Engineering Review

EPC Planning & Community Development Department

Sterling Ranch Filing No. 2 and Sterling Ranch Phase 2 Traffic Impact Study SF-20-015 & SP-19-001 (LSC #184660) February 2, 2021

Sterling Ranch Filing No. 2 and Sterling Ranch Phase 2 Traffic Impact Study

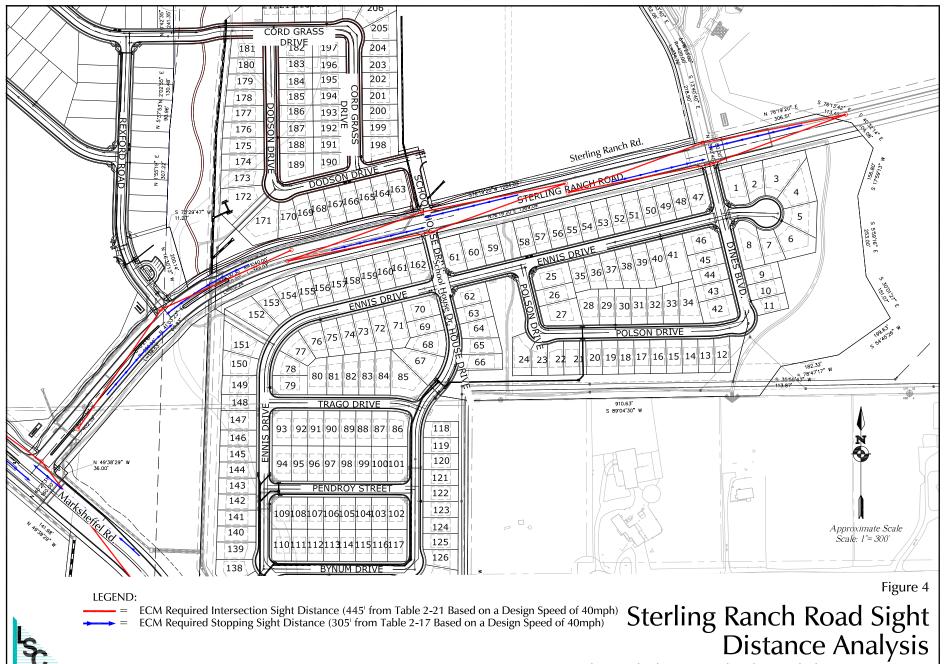
Initial?

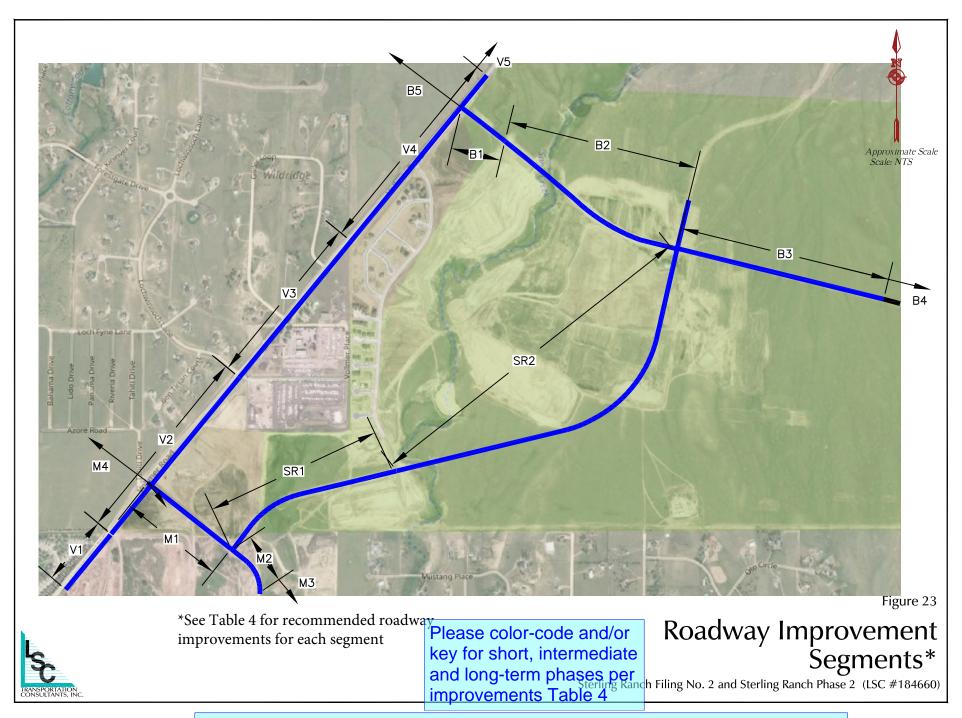
Are B2 and SR2 intermediate term (once the bridges are constructed)? Another approximate value that would be helpful is lot numbers/ADT for each phase.
